STAFF RECOMMENDATION

NCPC File No. 6037

**UNITED STATES BUREAU OF ALCOHOL, TOBACCO, FIREARMS AND
EXPLOSIVES, HEADQUARTERS BUILDING –
ROOFTOP COMMUNICATION ANTENNAS**
New York and Florida Avenues, NE,
Washington, D.C.

September 28, 2006

ATF HEADQUARTERS BUILDING ROOF PLAN INDICATING LOCATION OF POLE ANTENNAS

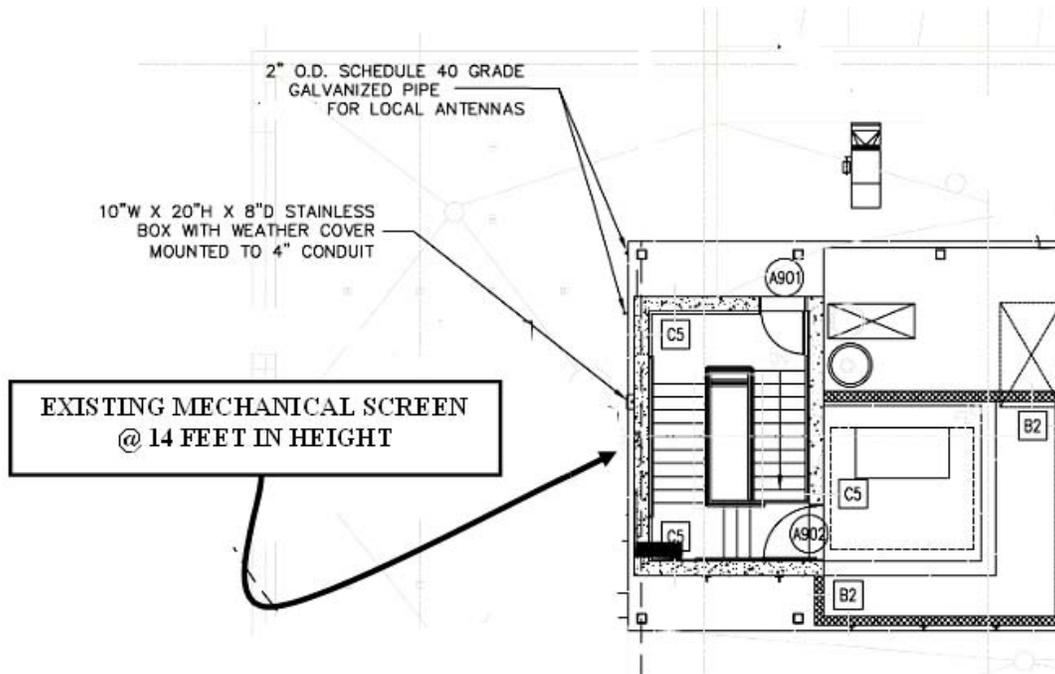
The **staff recommends that the proposed antennas be approved.** The applicant will locate the antennas to minimize their appearance, and they will not be readily apparent to the public at ground level. The antennas, with their small diameter and limited size, would not be visible from the street. The proposal is consistent with the Commission's Antenna Guidelines. Staff recommends that the antennas be approved for a period of 10 years, in concert with the Commission's recommendations in the Antenna Guidelines for buildings located outside the monumental core. Staff finds the extent of possible radio frequency (RF) radiation exposure generated from the antennas is very low and is well isolated from the general public by their location at the roof. However, staff does believe that the Commission should highlight to the General Services Administration that RF warning sign should be placed at the rooftop access areas in a visible location near doors at the penthouse to alert rooftop workers to the presence of RF radiation at that building location.

Recommends to the General Services Administration that access to the building roof should be controlled and locked if possible. Moreover, radio frequency (RF) non-ionizing radiation warning signs should be placed at the rooftop access areas in a visible location near all roof access doors.

ENLARGED ROOF PLAN SHOWING DETAIL AT WEST END OF MECHANICAL PENTHOUSE SCREEN WHERE POLE ANTENNAS WOULD BE LOCATED

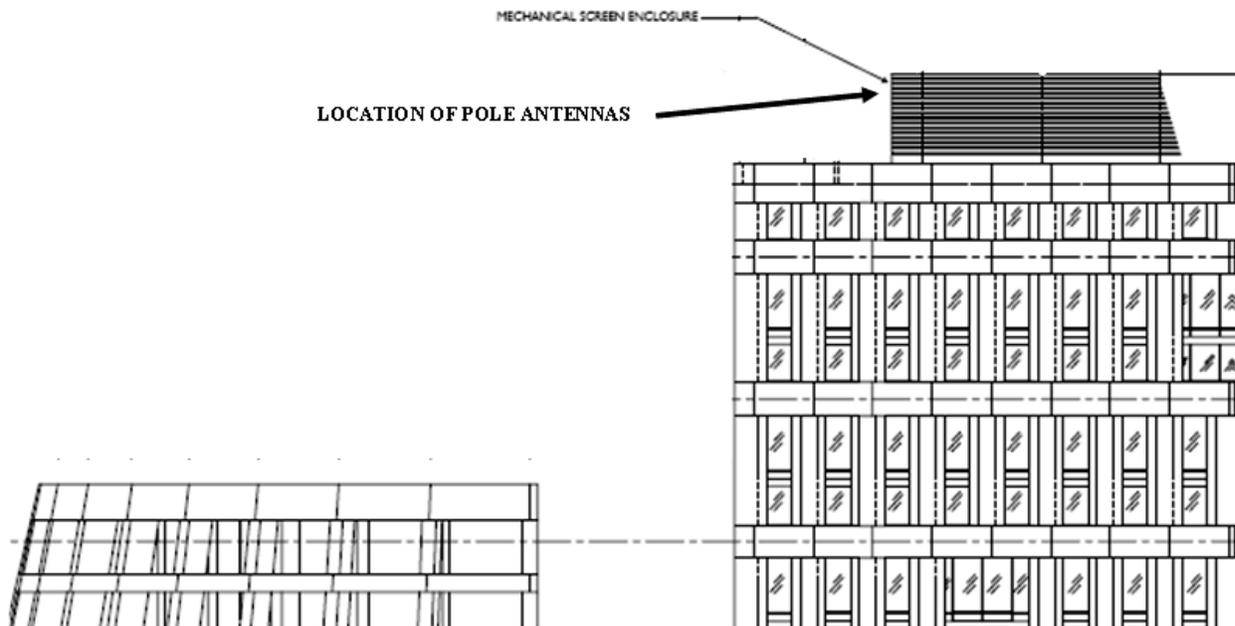
No areas off the roof, either extending down toward the streets or outward beyond the building perimeter, exceed either the general public or occupational worker exposure levels. None of the proposed antennas create an adverse exposure level exceeding the 100-percent MPE beyond five feet to eight feet distance from the antennas. No person can reach less than that distance toward the antenna locations due to their position on the vertical side of the mechanical screen elevated above the roof surface.

Staff recommends that the Commission highlight to the General Services Administration that RF warning signs should be placed at the rooftop access areas in a visible fashion near doors at the roof level to alert anyone at that location to the presence of RF signals.
